# Mobile Intel® Celeron® Processor on .13 Micron Process in Micro-FCPGA Package

Specification Update

*April 2004*

Document Number: 251309-019

**Figure 12. System Bus Reset and Configuration Timings**

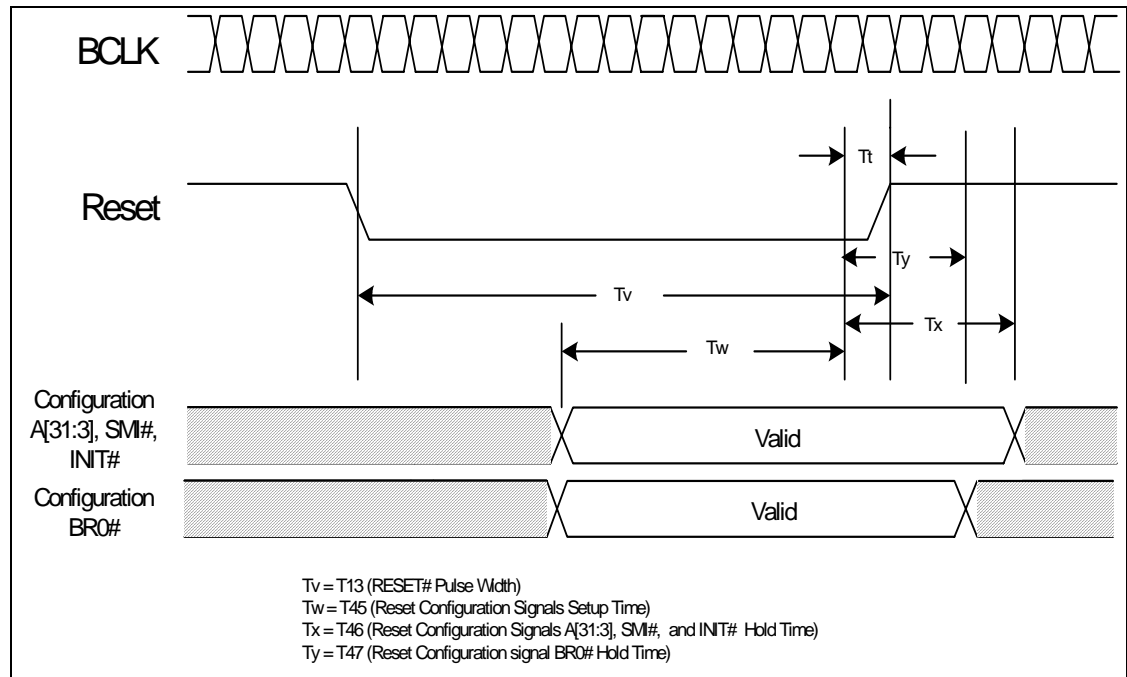
The BR0# maximum hold time has changed to 2 BCLKs. This change will be shown in the “System Bus AC Specifications (Reset Conditions)” table and “System Bus Reset and Configuration Timings” figure of the *Mobile Intel® Celeron® Processor on .13 Micron Process in Micro-FCPGA Package Datasheet*. This change will be incorporated in the next revision of the datasheet.

The following figure will be modified to reflect this change:

T# Parameter	Min	Max	Unit	Figure	Notes
T45: Reset Configuration Signals (A[31:3]#, BR0# INIT#, SMI#) Setup Time	4		BCLKs	13	1
T46: Reset Configuration Signals (A[31:3]#, INIT#, SMI#) Hold Time	2	20	BCLKs	13	2
T47: Reset Configuration Signal BR0# Hold Time	2	2	BCLKs	13	2
